ZALO KNITTING LIMITED

29 July 2025

2. Observation

Observation-01: High stress in the column and foundation, which requires immediate design review (Old Production Building).

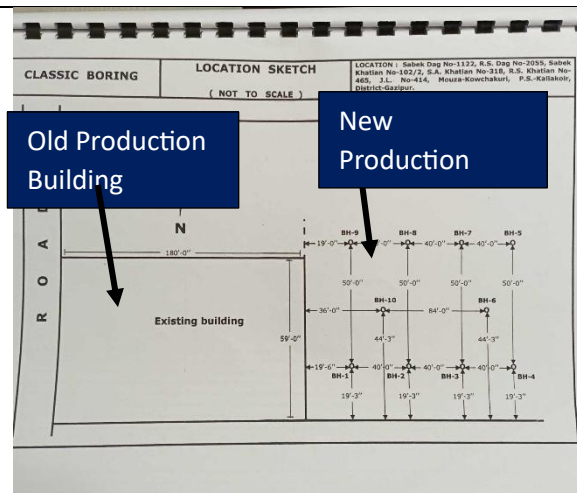
Description: Cursory calculation indicates high stress in the column, and punching shear of the foundation exceeds the normal design limit at the marked locations, considering the live load of 3 kPa, concrete strength 15.5 MPa (Column), 11 MPa (Footing) from the available core test report of the column and foundation, and minimum rebar strength 248 MPa.

Also, the calculation indicates that the bearing stress in the marked footing exceeds the normal design limit, considering the allowable soil bearing capacity of the adjacent “New Production building” (1 tsf, FoS:3).

1. The two PVC water tanks on the roof and the stair roof at the 4-storied extension parts must be removed/relocated with immediate effect.
2. The roof (Open to Sky) should remain 0.5 kPa live load, and the live load of the 1st floor, 2nd floor, and 3rd floor must not exceed 1.0 kPa; the live load in the stairs must not exceed 4 kPa.
3. An interim live load plan must be prepared by the consultant and used by the factory with immediate effect.
4. A Detailed Engineering Assessment (DEA) must be commenced immediately.
5. Review design, load column, and foundation stress.
6. Produce and actively manage a loading plan according to the floor capacity.

SECTION X9-X9

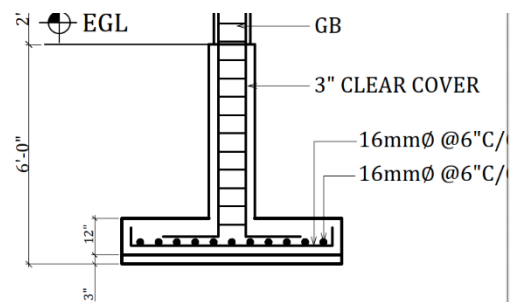
Description: In the provided as-built drawing, the thickness of footing F10 was shown as 300 mm, but after earth excavation, the footing thickness was found to be 300 mm~425 mm (with a slope), 300 mm~375 mm (with a slope), 300 mm~400 mm (with a slope). The building engineer is required to survey the whole structure and produce an accurate as-built drawing.

SECTION X1-X1

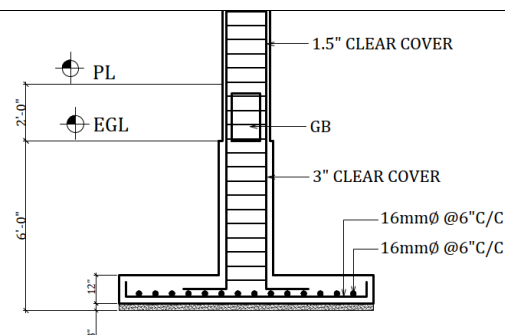
Description: In the provided as-built drawing, the thickness of footing F-2 was shown as 300 mm, but after earth excavation, the footing thickness was found as 450 mm. The building engineer is required to survey the whole structure and produce an accurate as-built drawing.

Observation-06: Unclear separation between Old Production Building and New Production Building on several floors.

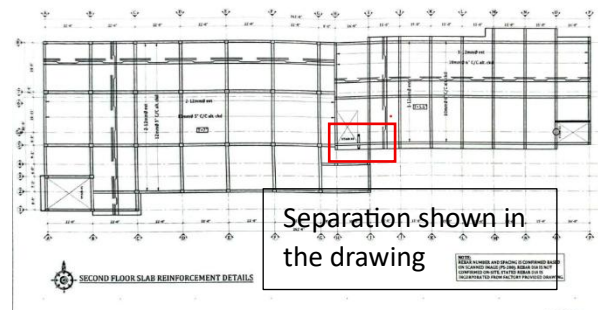
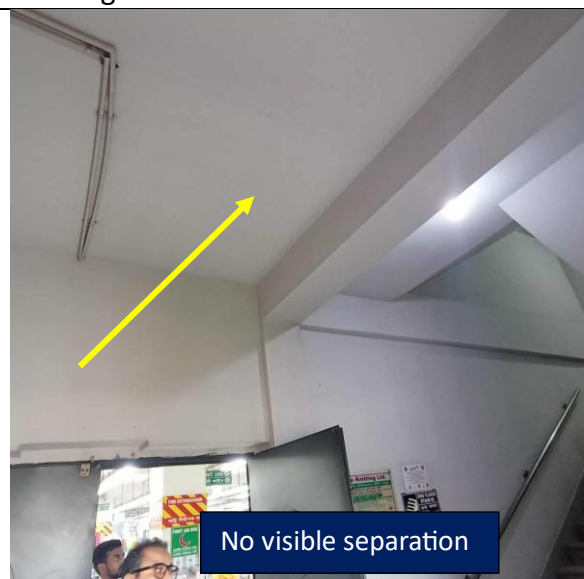
Description: As per the provided drawing Old Production Building and New Production Building are separated along the marked line, but the separation was not visible on several floors. The building engineer is required to verify the separation between two buildings.

Observation-15: Incomplete as-built drawing (RMS Room, Fuel Room, Fire Pump Shed).

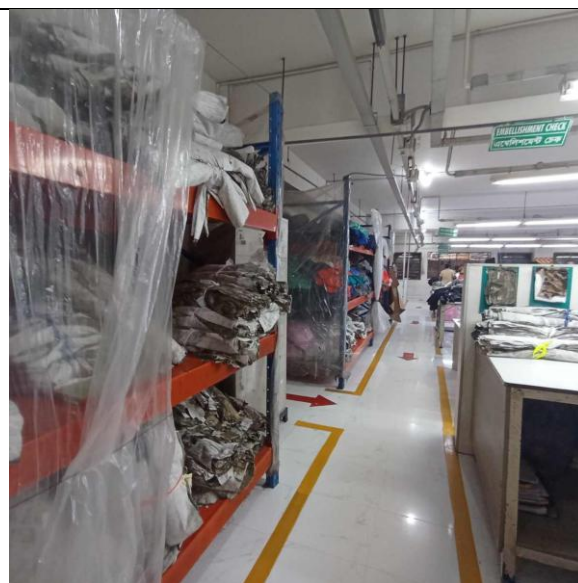
Description: A Full set of as-built drawings was not available for any of these structures. The building engineer produces a full set of as-built drawings.
